**SUBJECT:** NuScale Power, LLC Submittal of Topical Report TR-121172, Revision 1, on behalf of CFPP, LLC for the “Carbon Free Power Project (CFPP) Nuclear Quality Assurance Program Description,” Revision 003 (Nonproprietary)

# Carbon Free Power Project, LLC

## Quality Assurance Program Description

Revision 1

**Figure I.1-1**  
**CFPP Organization**

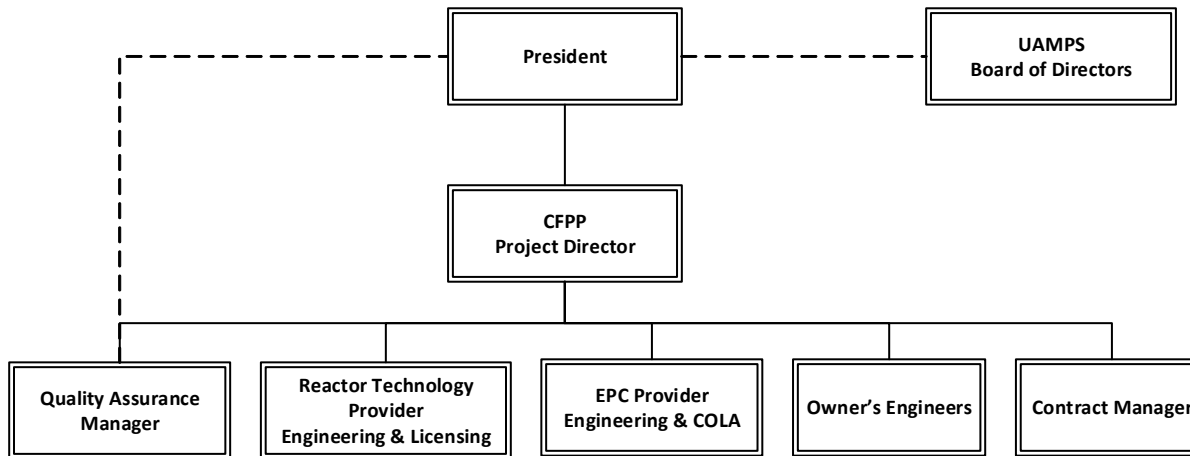
- The NRC staff referenced one SRP Section 17.5 acceptance criterion regarding a description of the periodic evaluation of significantly delegated activities and the individuals/companies performing these activities. The NRC staff understands that CFPP has contractual agreements with various entities supporting the development of its COLA and noted that this information is not in the submittal and that Figure II.1-1 in the submittal is unreadable to determine which entities support the CFPP activities.

- CFPP Response: A description of the periodic evaluation of significantly delegated activities and the companies performing these activities are provided in Section 2 Quality Assurance Program of the CFPP QAPD Revision 003. Figure II.1-1 (renumbered as Figure I.1-1) has also been revised in the enclosed CFPP QAPD Revision 003.
